GOVERNMENT OF THE DISTRICT OF COLUMBIA
Board of Zoning Adjustment

Appeal No. 18615 of 5333 Connecticut Neighborhood Coalition, et al., under 11 DCMR §§ 3100 and 3101, from April 3, 2013 and May 28, 2013, decisions by the Department of Consumer and Regulatory Affairs to issue building permits (FD1200052, SH1200128 and B1208792,) authorizing the construction of an apartment building in the R-5-D District at premises 5333 Connecticut Avenue, N.W. (Square 1873, Lot 128).

DECISION AND ORDER

SK-ZNG

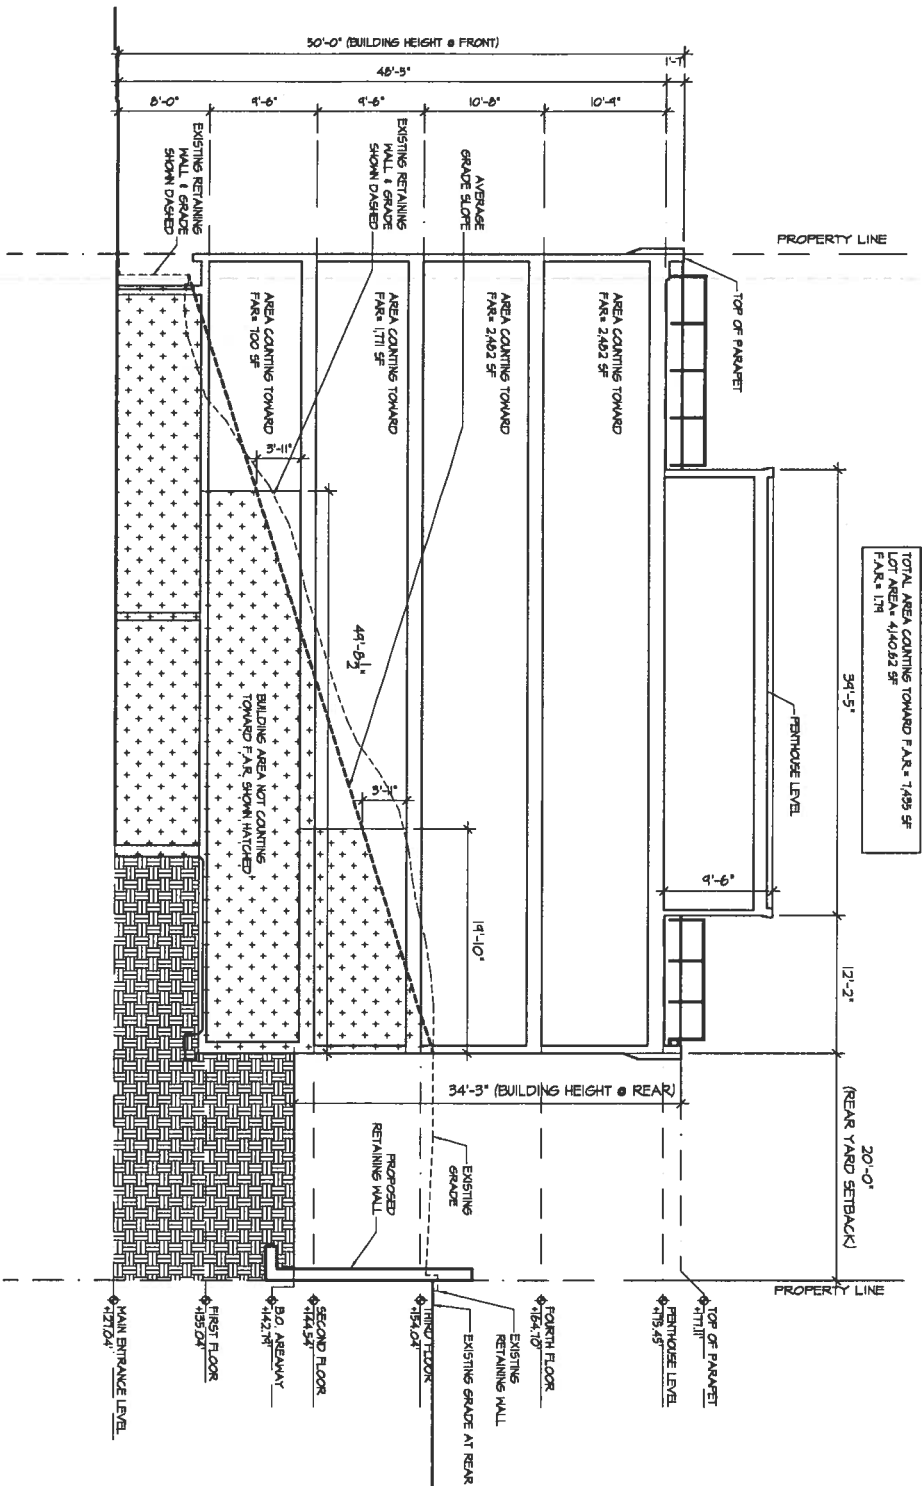
After reviewing your submitted section drawing labeled SK-ZNG, dated 6/6/11, I conclude that the drawing accurately depicts the use of the Grade Plane Method, and the shaded areas may be deemed as a cellar and excluded from the FAR calculation. If the resultant floor area contains 7,435 square feet of gross floor area (1.79 F.A.R.), this is less than the maximum 1.8 FAR and would comply.

As depicted in the provided section labeled SK-ZNG, the height at the middle of the rear of the proposed structure as measured from mean finished grade, based on the drastic change in topographical elevation, to the highest point of the main roof or parapet is thirty-four feet and three inch (34 ft- 3 inches) which results in a minimum rear yard setback requirement of eleven feet and five inches (11 ft- 5 inches) ($\text{height at mean finished grade} \times 4 \text{ inches} = 137 \text{ inches} \div 12 = 11.41\text{ft}$). Therefore the 15 foot rear yard standard applies.

SK-Z1

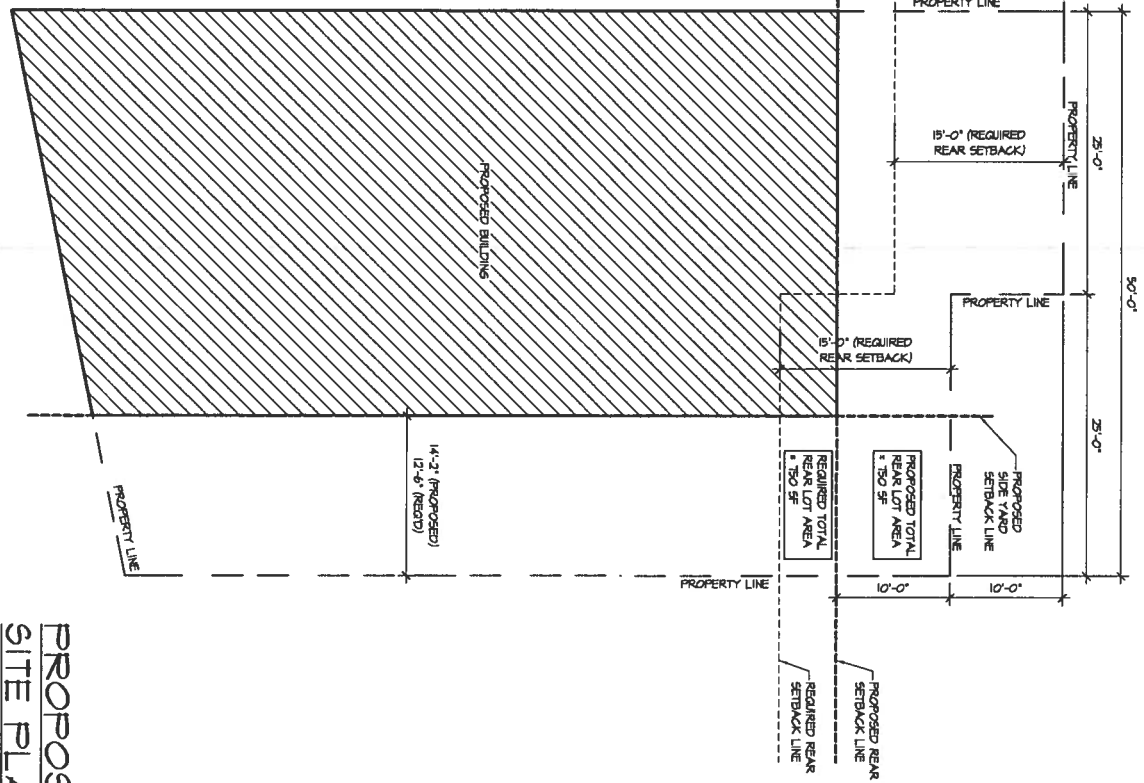
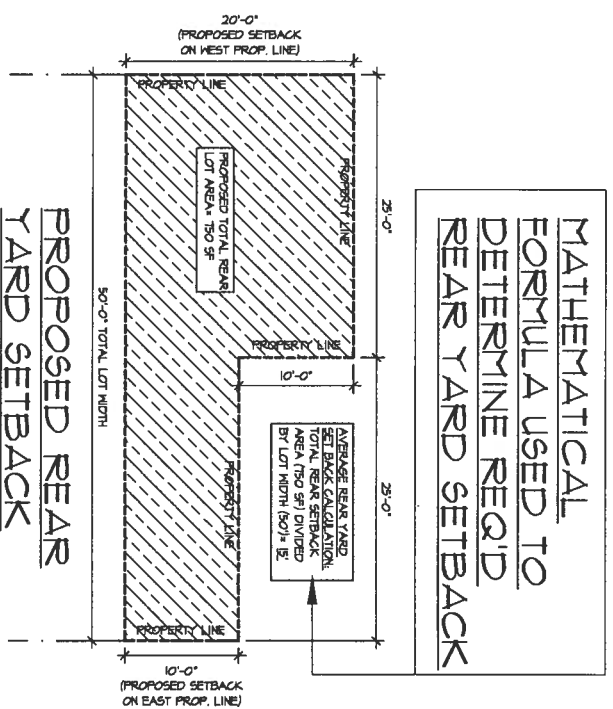
Total square feet in area of portion of lot behind a line drawn at the farthest point of the rear building line parallel to the rear property lot line, divided by the linear distance of the line so drawn at the points at which the line intersects the two side property lot lines; consistent with the graphic and numerical illustration attached as drawing SK-Z1.

Based on this drawing and applicable calculations, I have determined that the proposed depicted rear yard setback complies.
